8-201-PFA-10 new edition

– wiring changes between 2 versions.

Date : 2020/12/24

8-201-PFA-10 wire change

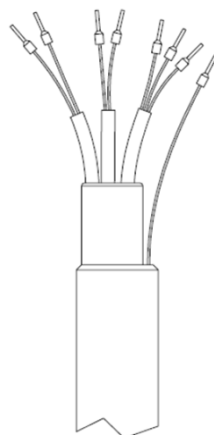
- 8-201-PFA-10 changes wire from 9 cores to 8 cores.
- EC-4110-ICON backside changes accordingly.

Description	Heat-shrink tube color	Wire color	Wire description
Drive	Red	Red	Drive — H
		Brown	Drive — L
Receive	Black	Orange	Receive— H
		Black	Receive— L
Temp.	Green	Yellow	PT1K RTD-A
		Green	PT1K RTD-B
		Grey	PT1K RTD-B
Shield	Clear	Clear	Shield
